Architectural Review Board Agenda
4:00 PM Wednesday, July 2, 2025
Sussex Civic Center – Committee Room Second Floor

TO: Architectural Review Board
FROM: Gabriel Gilbertson, Community Development Director
RE: May 7, 2025 Architectural Review Board
DATE: Friday, June 27, 2025

- I. **Roll call.**
- II. **Consideration and possible action on the ARB minutes of April 2, 2025.**
- III. **Discussion and possible action on a Plan of Operation, site plan, landscape plan, architecture plan, and lighting plan for Scooter's Coffee located at the southwest corner of Business Dr and State Highway 164.**

Scooters Coffee has submitted an application to construct a 678 square foot drive-through coffee shop in the Highlands Business Park. The site is zoned BP-1 Business Park District with a PDO allowing for uses permitted in the B-2 Regional Business District. The proposed use is permitted per Section 17.0417(1)(b).

A2.1

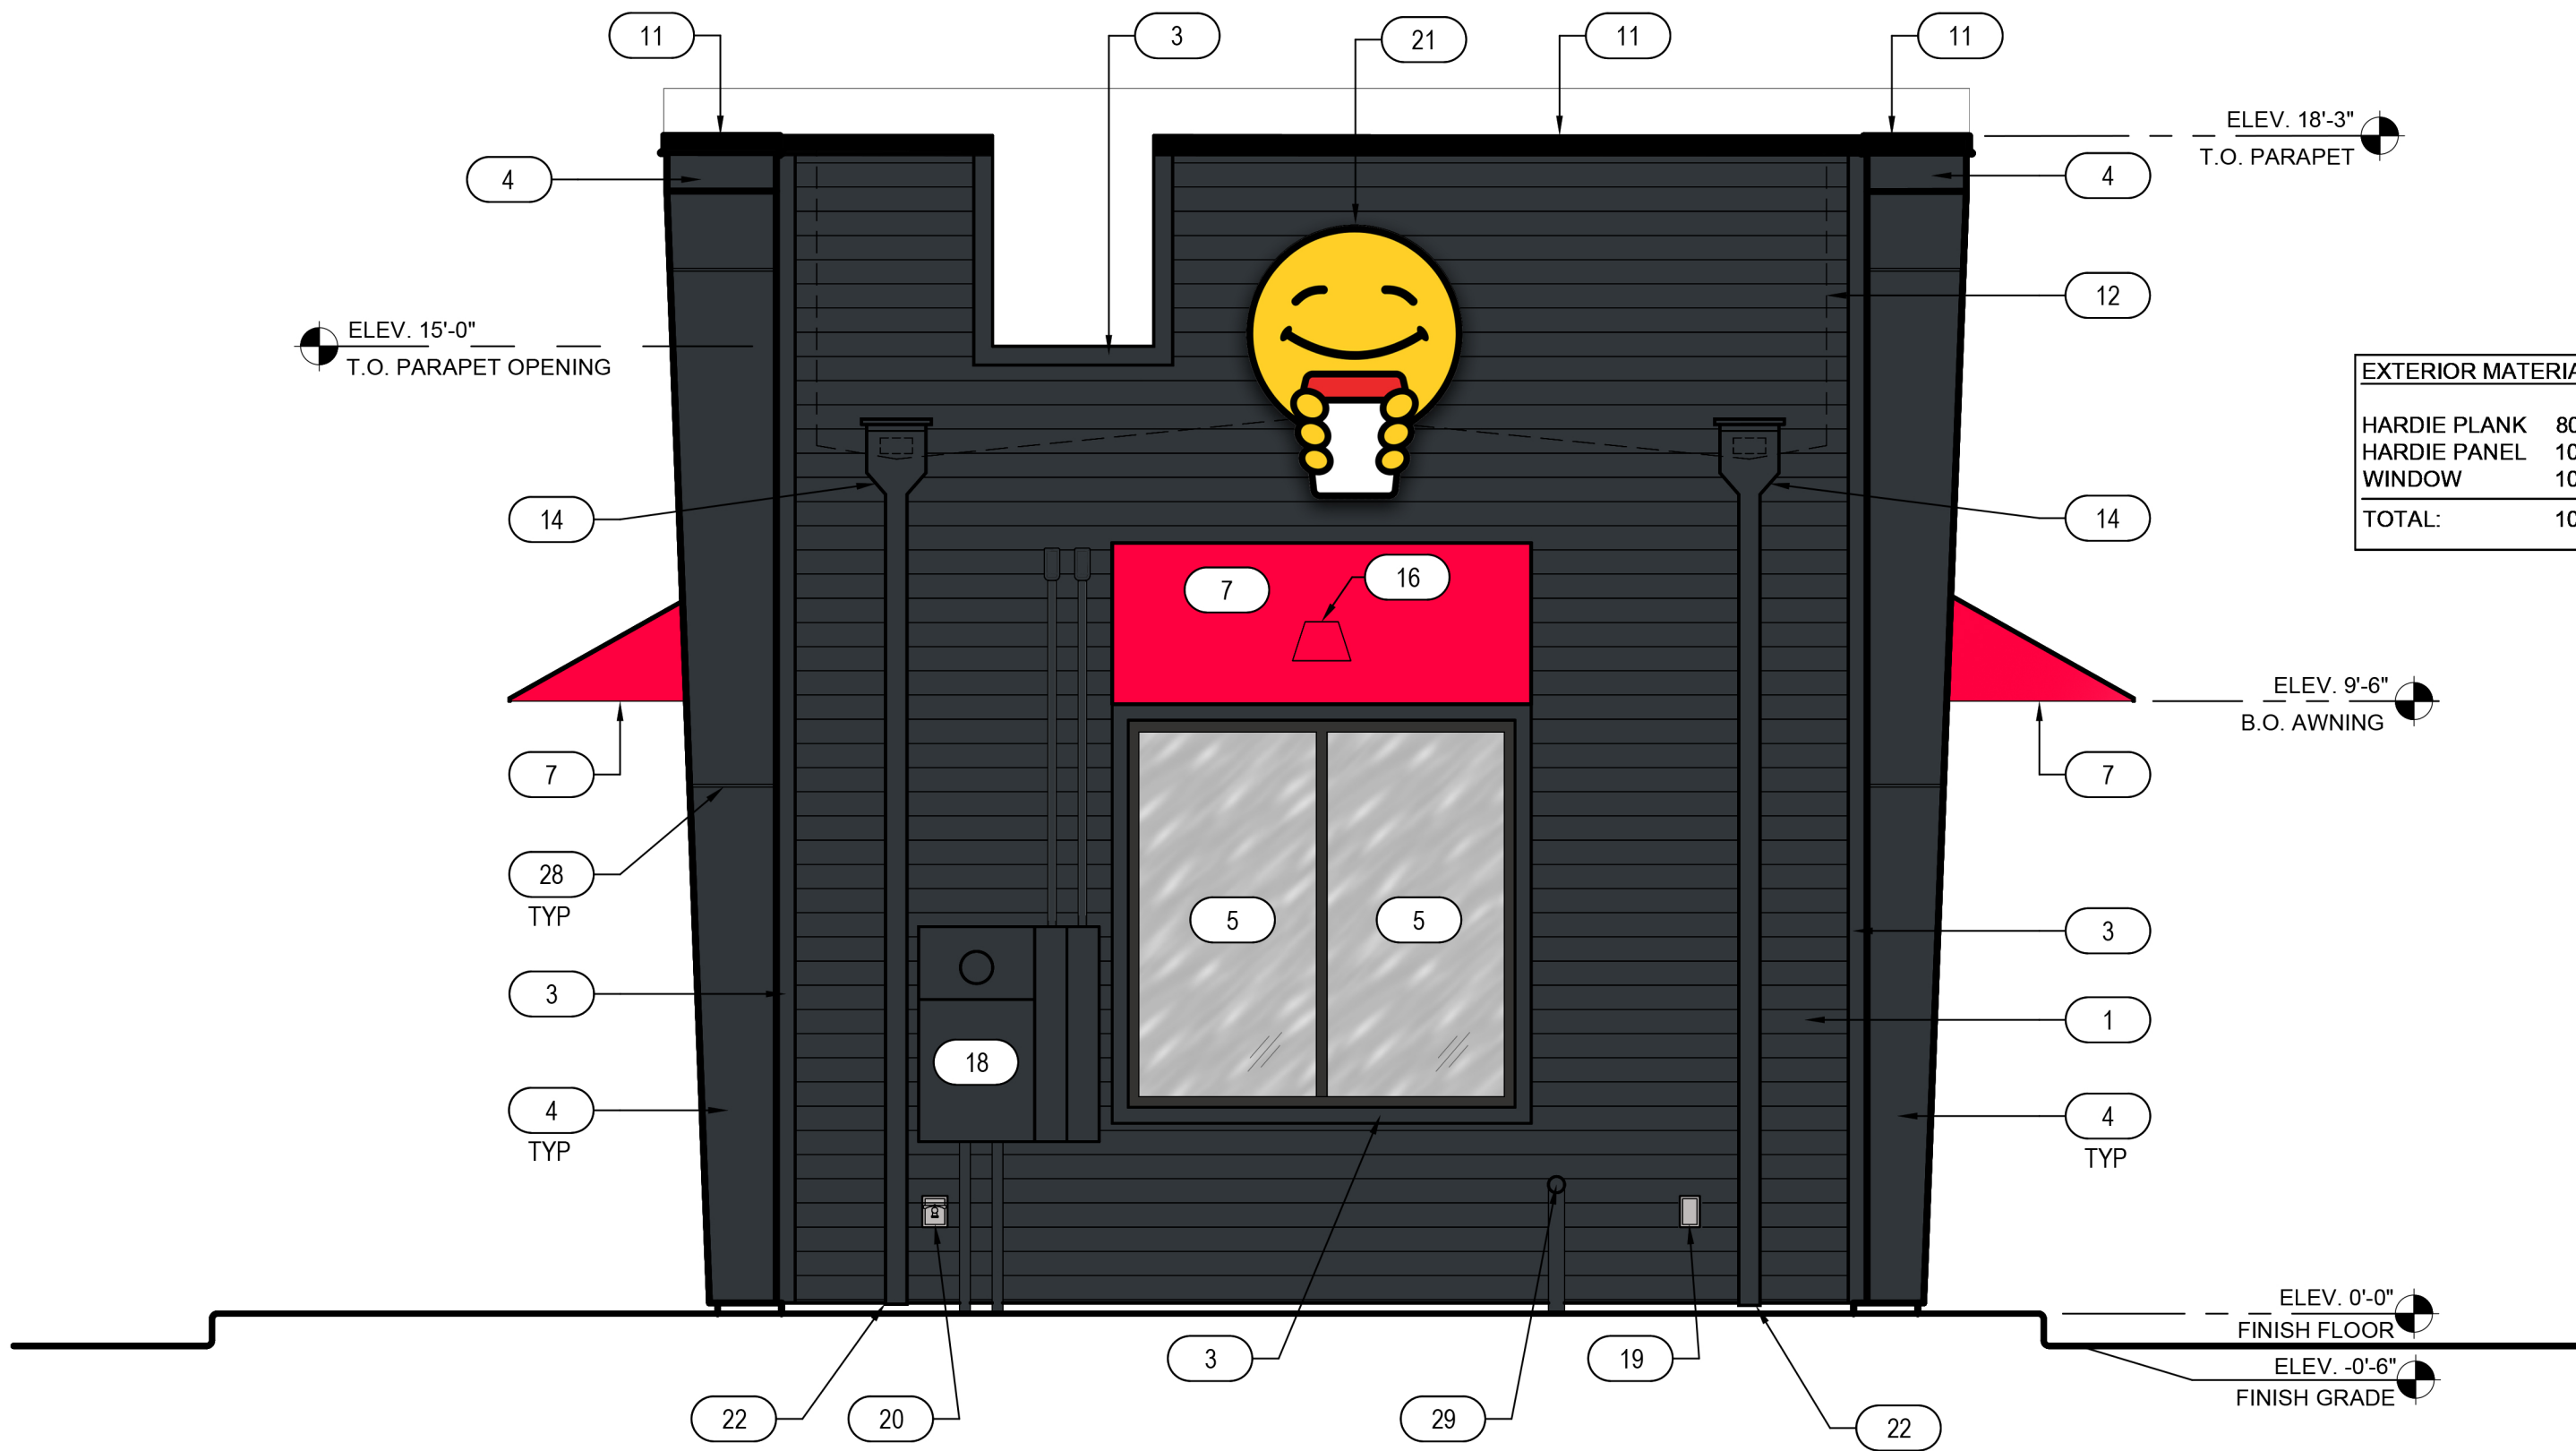
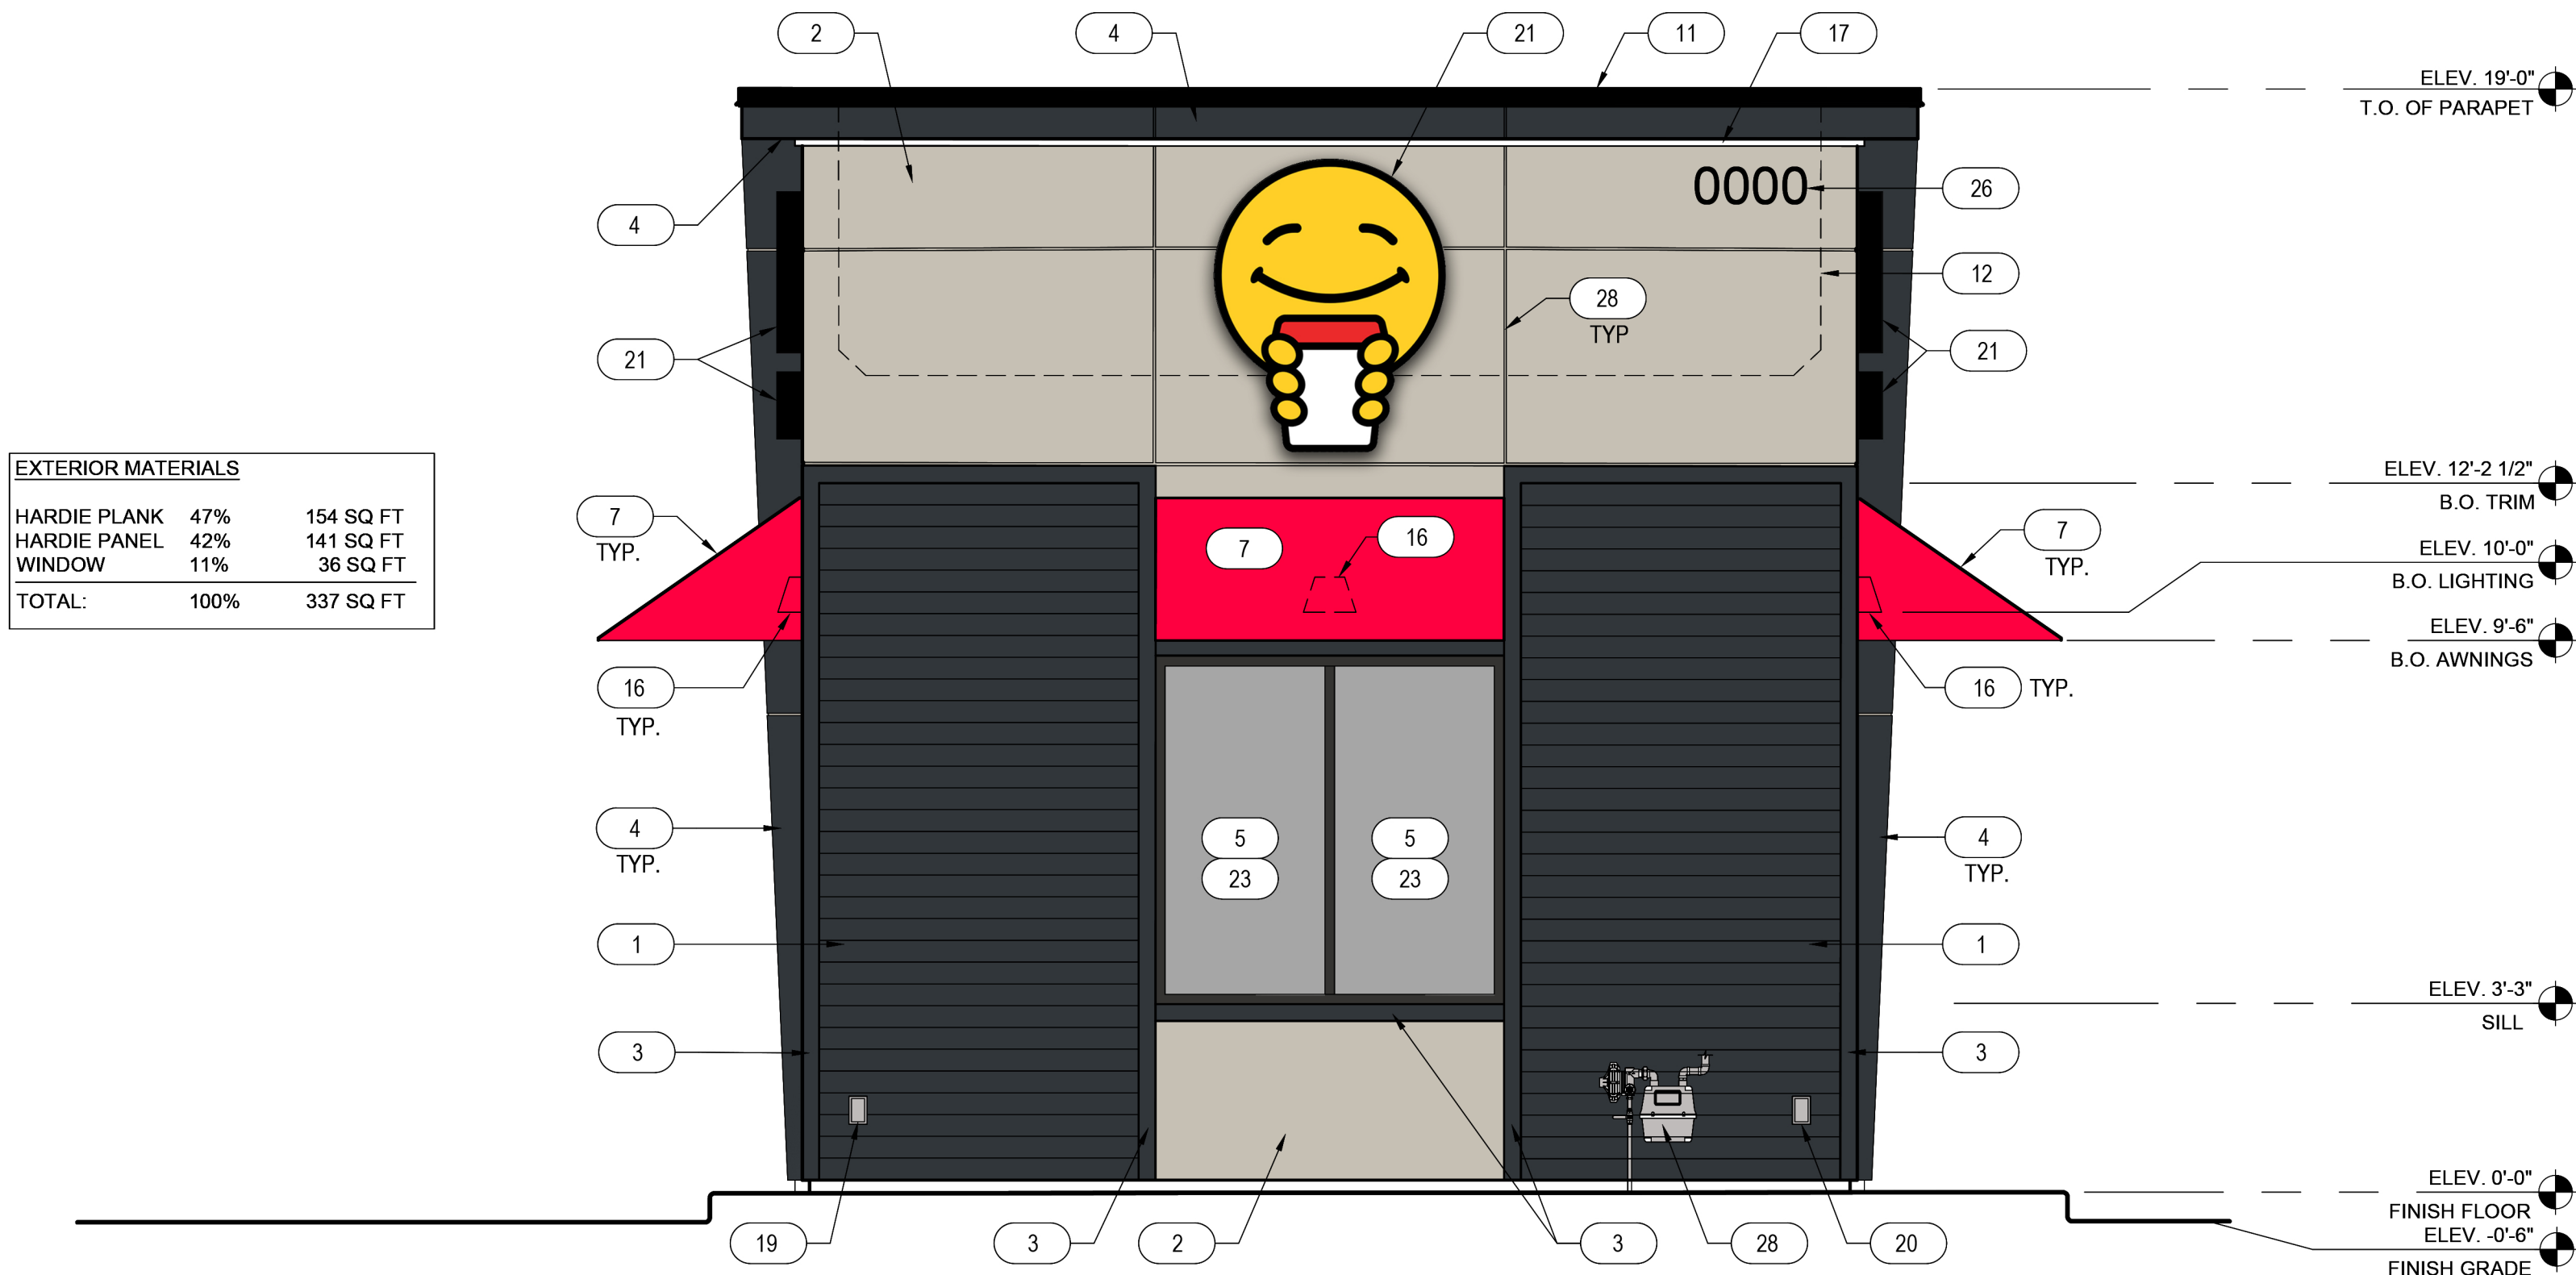
- Building meets height and required setbacks.
- Roof top units are to be screened from view.
- Materials to be used meets the Design Standards.
- Revised elevations that meet 33% window and door openings are required.
